JANESVILLE CITY COUNCIL

LICENSE AGENDA

SUBJECT: Amendment to licensed premise to include an outdoor patio area for Sidekicks Saloon, 3502 Milton Avenue.

SUBJECT: Review of site plan for an outdoor patio for Sidekicks Saloon, 3502 Milton Avenue, Janesville, Wisconsin

INTERIOR OF
RESTAURANT

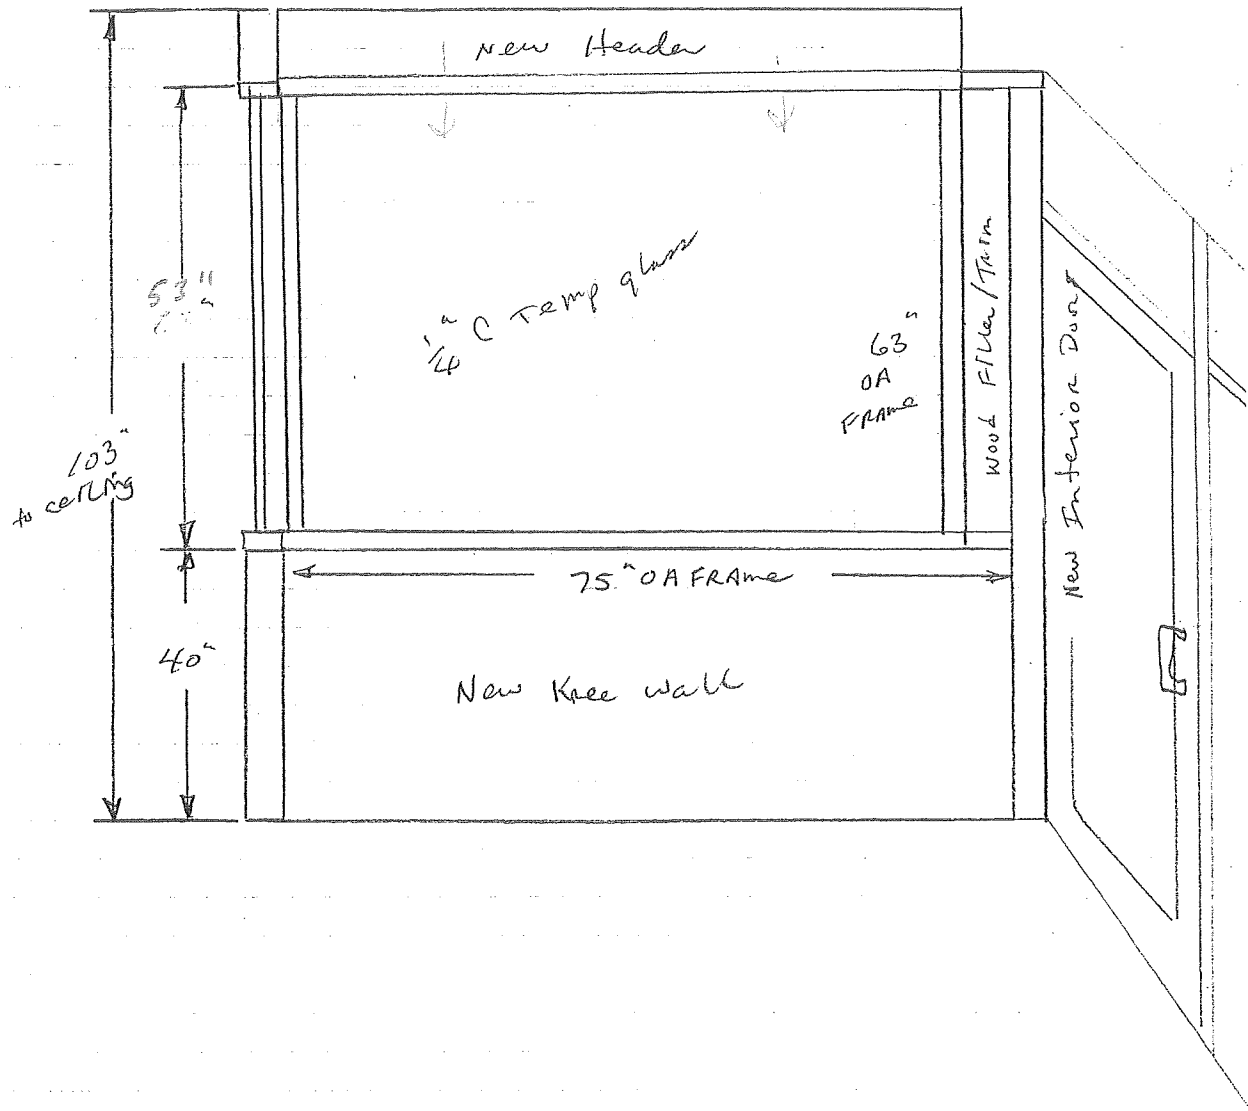
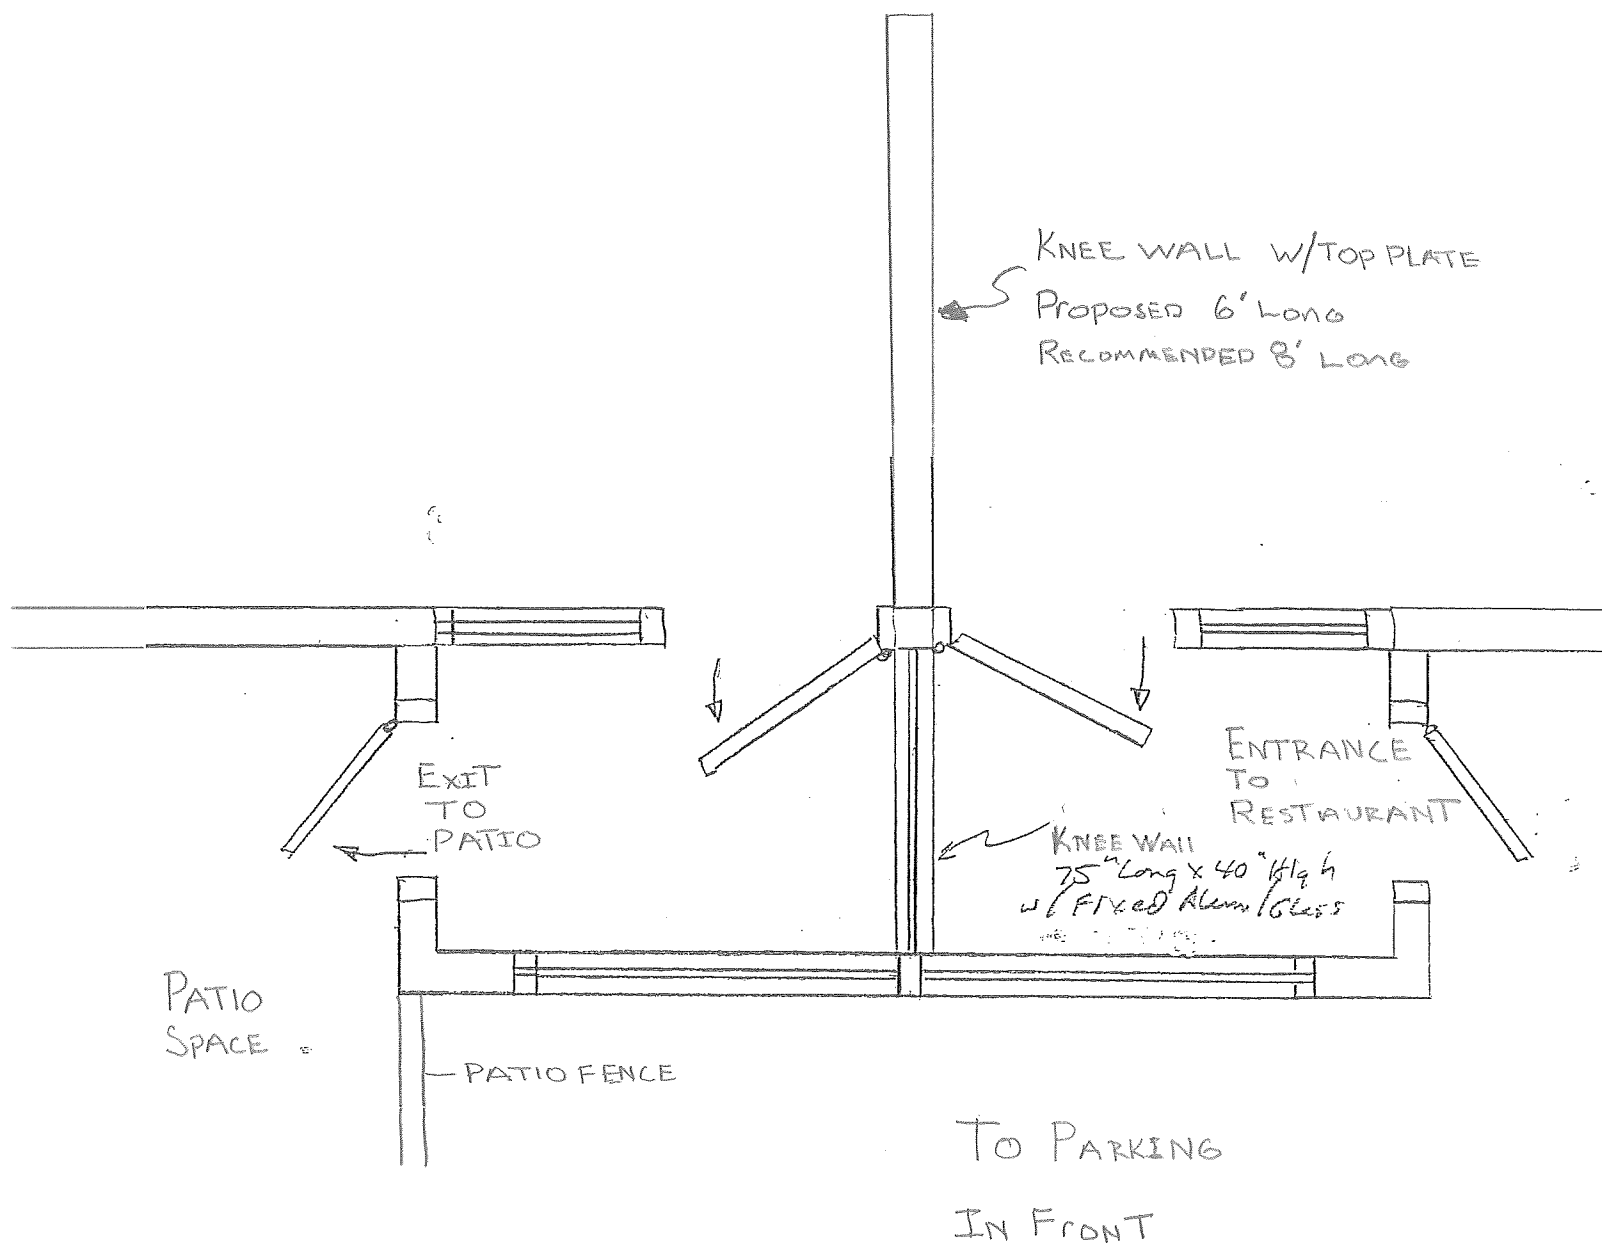
Staff was concerned about the request of the petitioner which included only a six foot long wall to separate the entrance into the tavern from the point at which a patron could enter the patio. The concern was based on what distance into an establishment must a patron travel to be properly identified by staff before they enter into the patio area. Essentially staff did not feel that

a six foot divider was sufficient especially given that there is intervening space between the bar area and the entry to the patio.

The proposed configuration is unique in that a patron does not need to traverse a great length of the bar or restaurant to get to the patio area. The patron would walk six feet (as proposed) into the facility, go around the half wall and walk six feet out into the patio area. A total distance of twelve to fifteen feet would be all that was needed to enter the patio. Given the configuration of the building it is difficult to retrofit a new door in the exterior wall without significantly affecting seating within the facility. There is also a half wall with stained glass on top that would limit visibility of people entering the space.

After further discussion by Staff and review of the request by the Alcohol License Advisory Committee, it was determined and ultimately recommended that the requested patio should be approved with two conditions, that the dividing wall between the entry side and exiting to the patio be eight feet in length (rather than the originally requested six feet) and the stained glass on the top of the partial wall between the bar and the entry way be removed to increase the visibility of the entry to the patio.

ADDITION OF GREEN SPACE – Revised 3-30-10

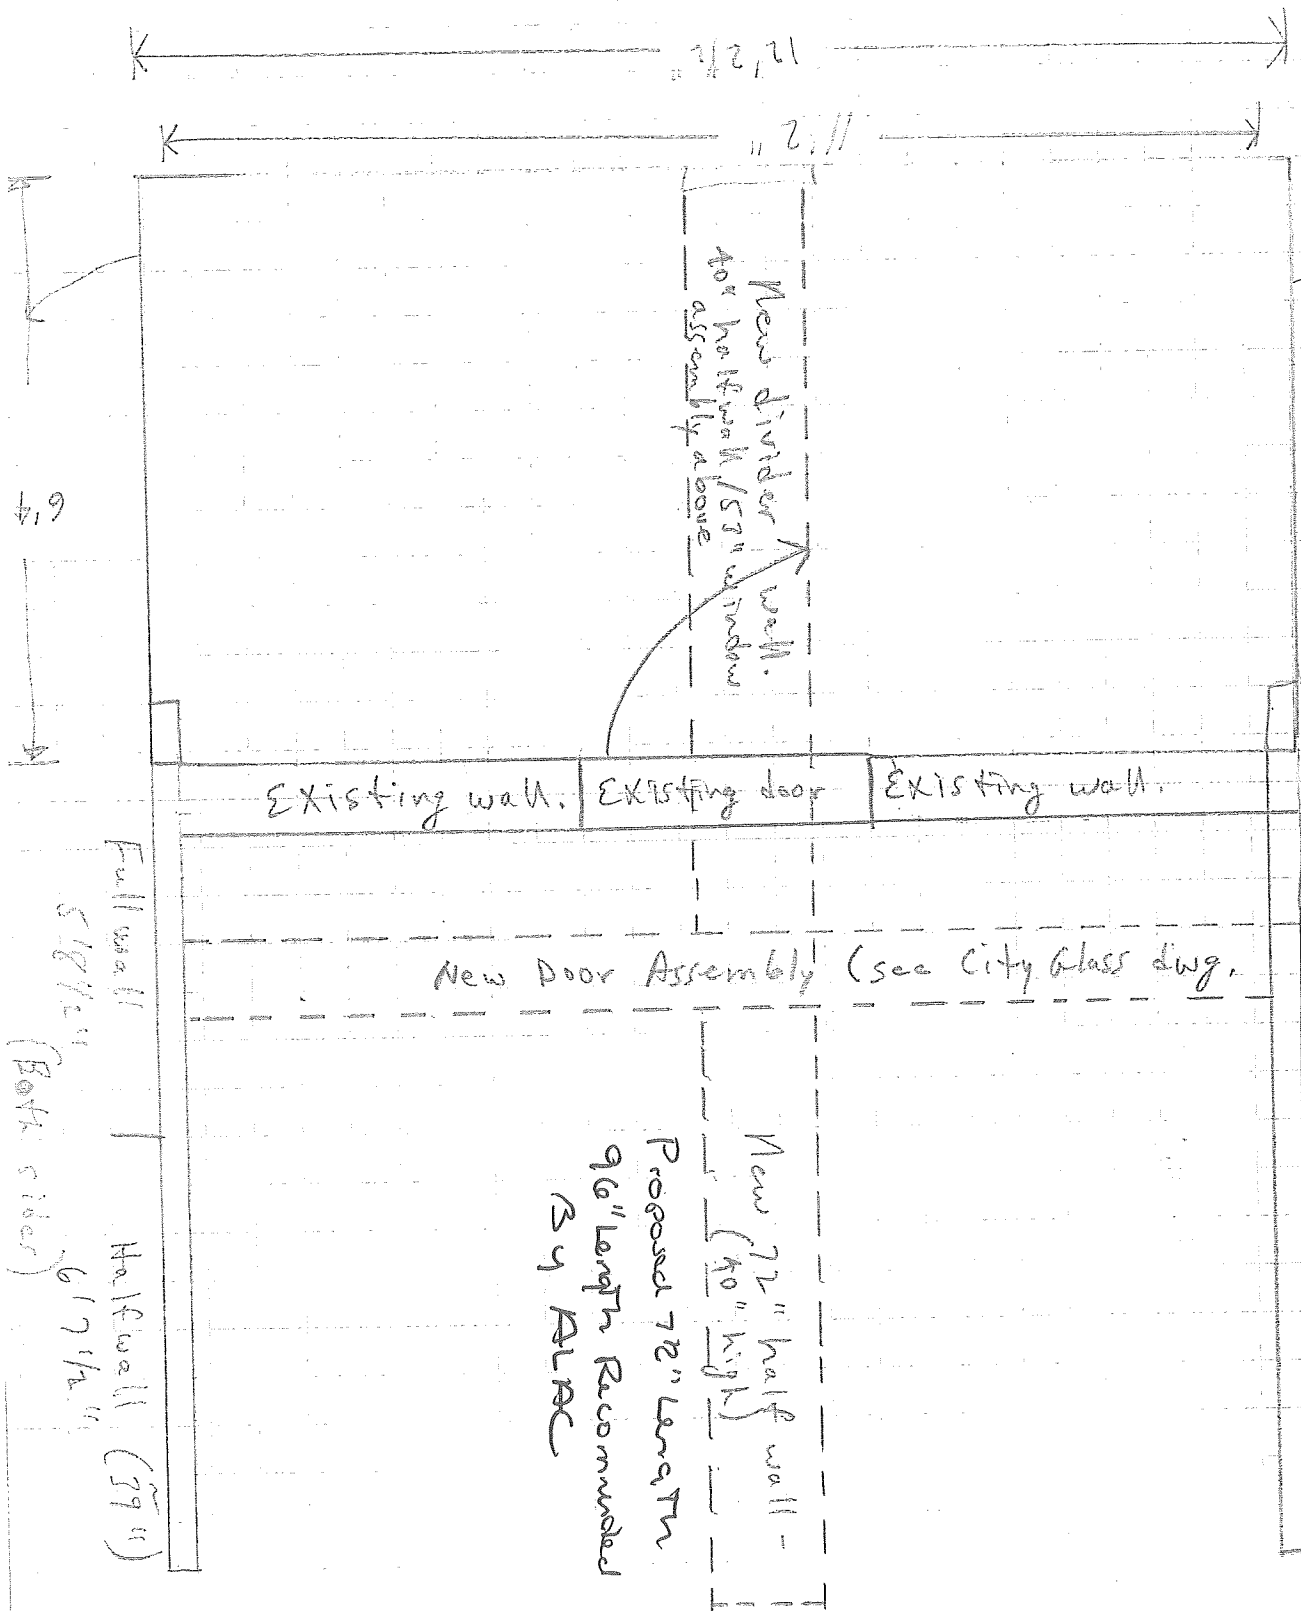
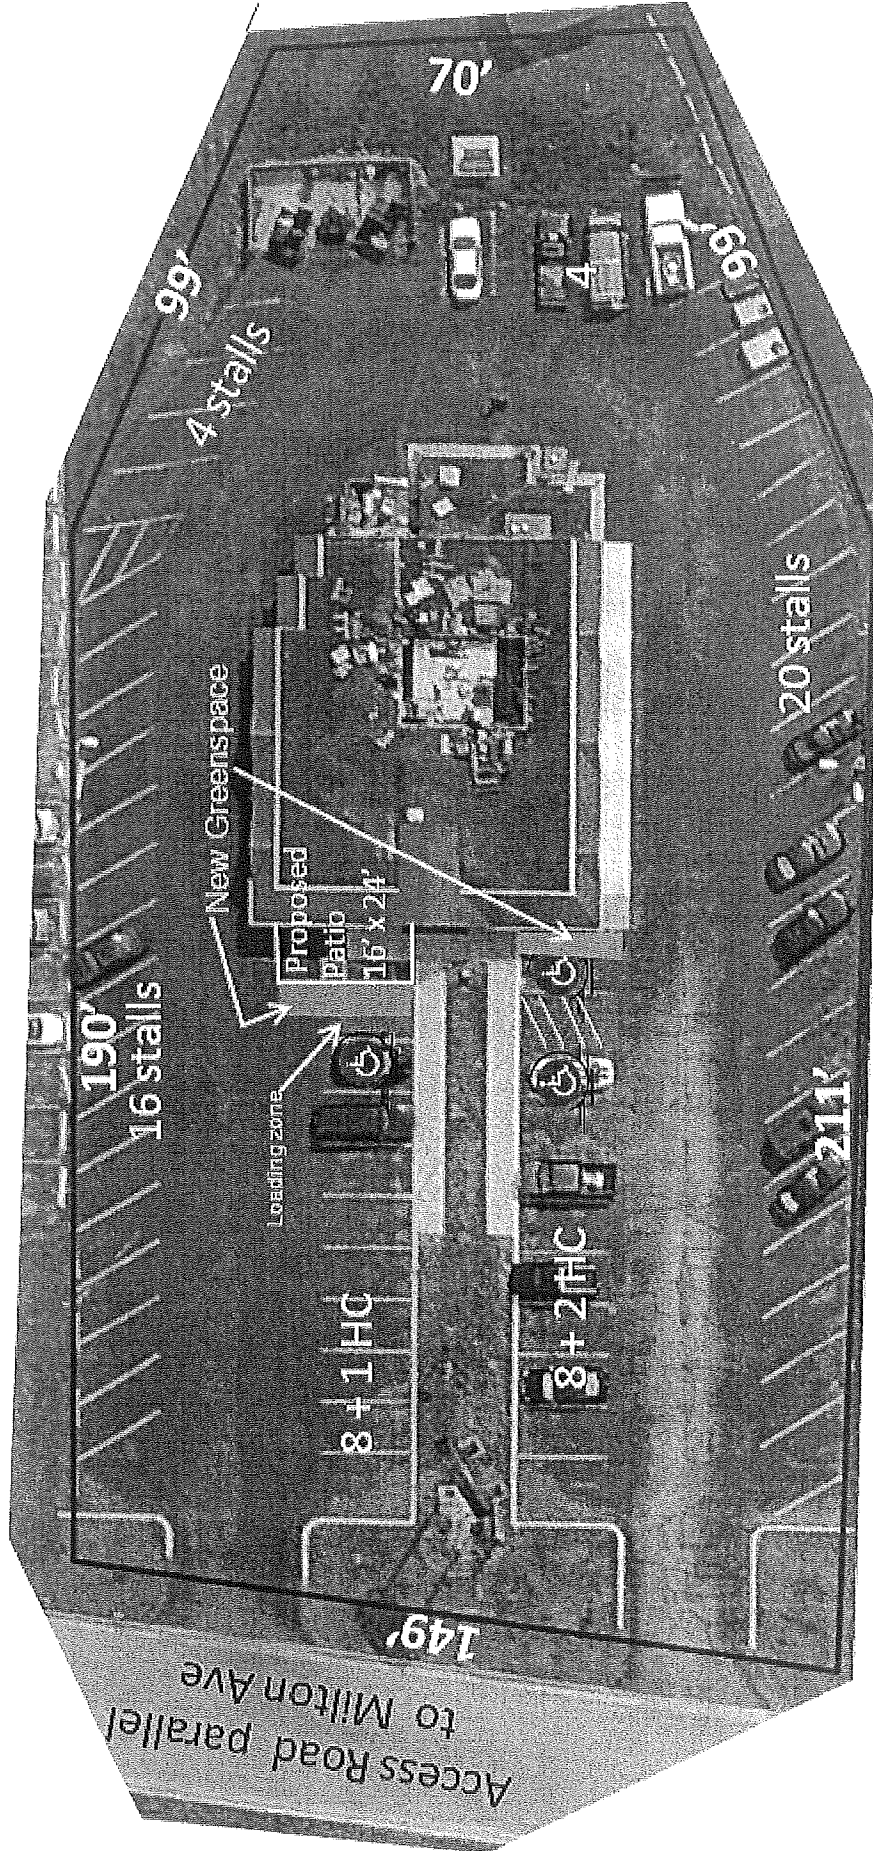
1. The off-street parking standards require one parking stall for each 35 square foot of net floor area for serving customers and one for each employee based on the greatest number of employees on any shift. The net floor area is 1,720 square feet and you've indicated there would be 10 employees on the busiest shift; therefore, 59 parking stalls are required. The site plan provides 64 stalls which is an allowable number by ordinance standards.

2. When provided parking exceeds 50 stalls, three Barrier free parking stalls are required. There are currently two handicap stalls in the existing parking lot and a third stall is required. Please note that these stalls must be constructed to the applicable standards and properly signed (the existing signs do not meet ADA requirements). In addition, please note that those stalls and associated loading areas may not exceed a 1:50 grade in any direction.

3. The zoning ordinance for B4, Business Highway District requires that each property provide 20 percent greenspace on the site. The property is 39,953 square feet in area; therefore, the minimum greenspace requirement is 7,990 square feet. Fifty percent must be provided in front of the building. Currently the site does not meet these standards. I estimate that there is 3,711 square feet in front and 2,994 square feet on the sides and rear (a total of 6,705 square feet). Please revise the site plan to add some additional greenspace to the front of the site. (For example, you may be able to remove paving near the front of the building since the number of existing parking stalls exceeds the requirements. Please see the attached drawings dated February 9, 2010.)

7. Detailed building plans must be submitted for review for the patio, fence and new exterior door construction. Please note that the threshold between the patio and the building must meet ADA standards (less than 1/4 inch difference).

In addition, the existing north entrance door from the vestibule must be "closed off" and cannot provide an entrance/exit onto the patio. (Mr. Price is working with you and the city clerk on this matter.) Details for the patio fence enclosure must include elevations which depict the type of materials which will be used, the fence height (a minimum of 48 inches is required) and the location of the gate (exiting onto a level surface).
